Thermal Network Mini Hybrid Eyeball & Bullet Camera V2.630.00000000.7

Release Notes

Item	Description
Product model	Thermal Network Mini Hybrid Eyeball & Bullet Camera
Version	V2.630.00000000.7
Software package information	DH_TPC-BF1241-TB_MultiLang_PN_V2.630.00000000.7.R.211012.zip DH_TPC-BF1241-TB_MultiLang_NP_V2.630.00000000.7.R.211012.zip
OS requirement	None.
Release date	October 27, 2021

1.4.2 Fault Visualization

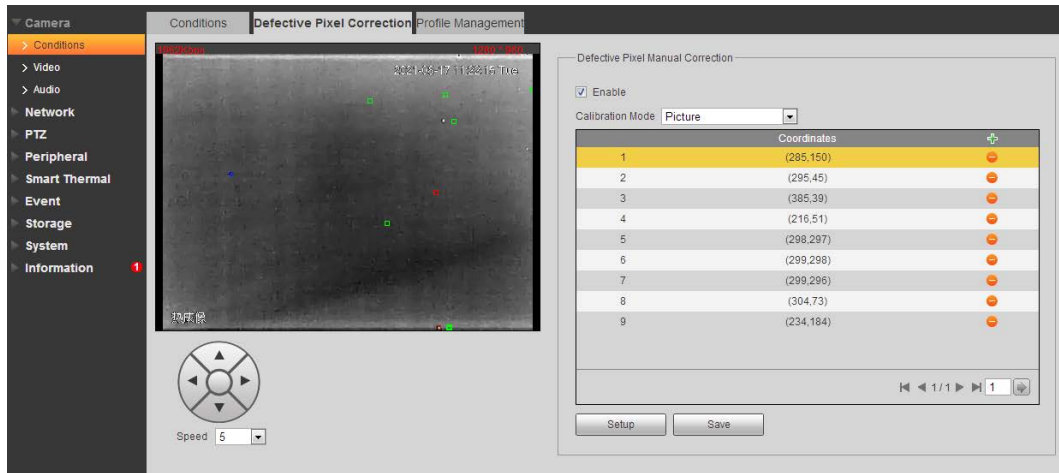
When the device fails, the OSD displays the fault type.

Fault code display is based on the fault level ranging from 0 to 7.

The fault level for visualization is 3 by default. When the fault level is between 0 and 3, the fault code is displayed. When the fault level is between 4 and 7, the fault code is not displayed.

1.4.6 Auto Temperature Measurement Mode

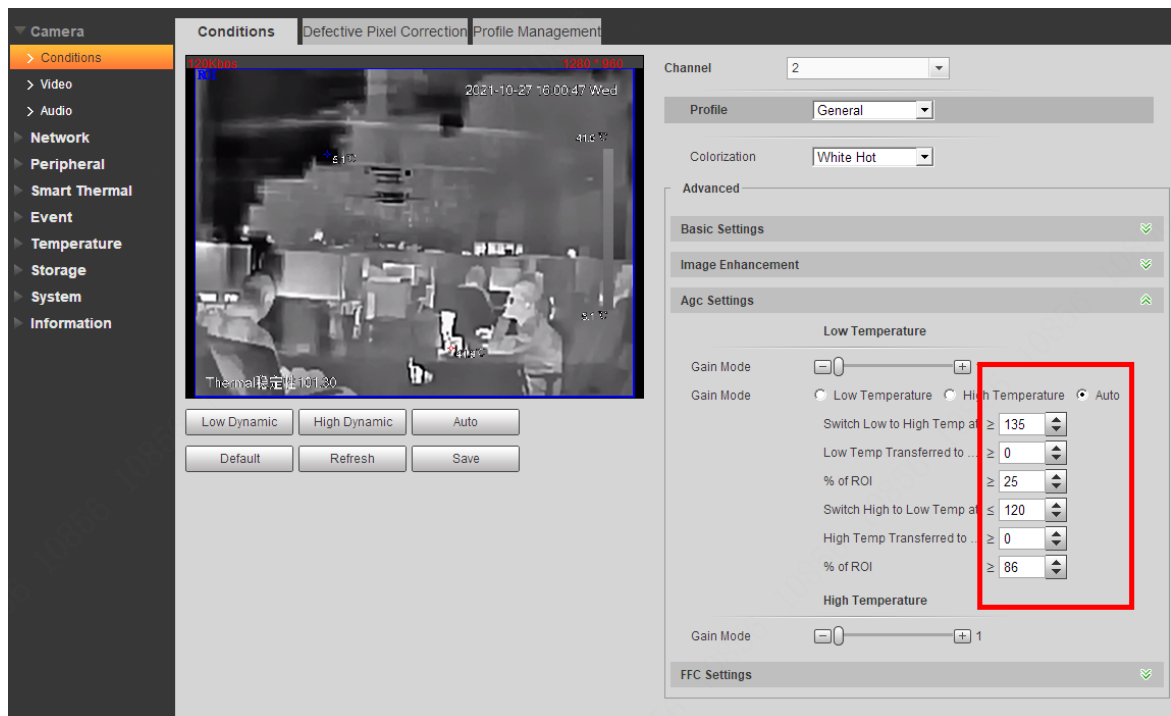
Added auto temperature measurement mode for devices with temperature measurement function.

1.4.7 Early Warning of Temperature Measurement

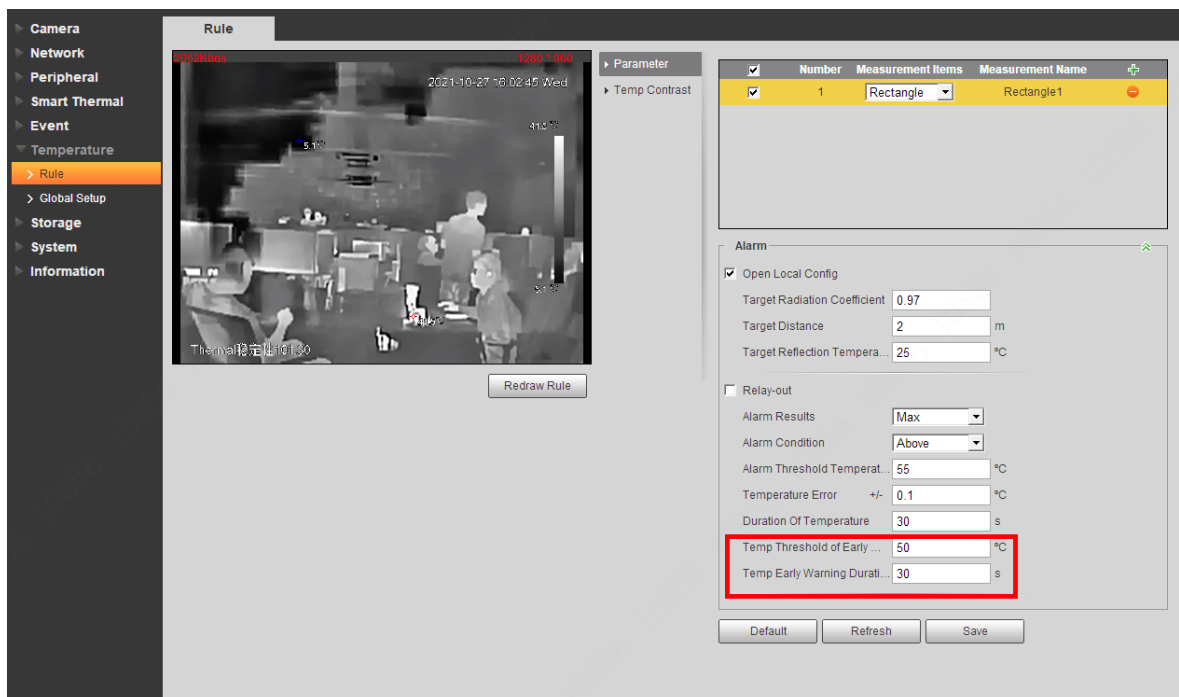
When the device detects that the temperature exceeds the early warning threshold, an alarm is triggered.

1.4.8 Exclusive Function Prompt

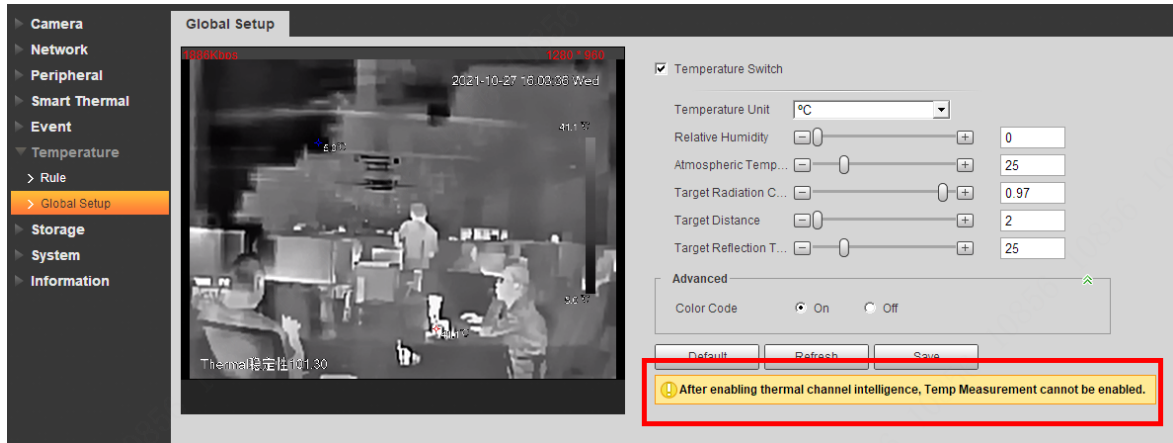
Added prompt when enabling thermal channel intelligence and temperature measurement at the same time.
